APPENDIX A: SITE INSPECTION CHECKLIST (NULINSPECTIE)

Project: Simonshaven DP2-4 (Nulinspectie)

Date 10 December 2025

Inspector: DNV – PJ Schutte

Figuur A.2 EM en LPZ zone indeling CDG en takhuisjes

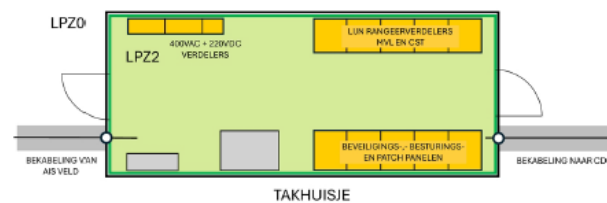
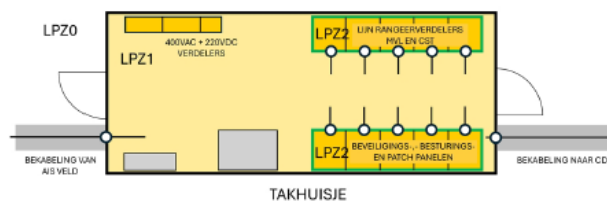
Report Finding: Page 18, Finding 7 ("EM/LPZ zonering CDG")

Text: *"Het EMC invoerraam in de AC ruimte lijkt niet consistent te zijn toegepast. Er zijn geen aardverbindingen vanaf het frame... zichtbaar."* (The EMC frame in the AC room... no earth connections visible from the frame).
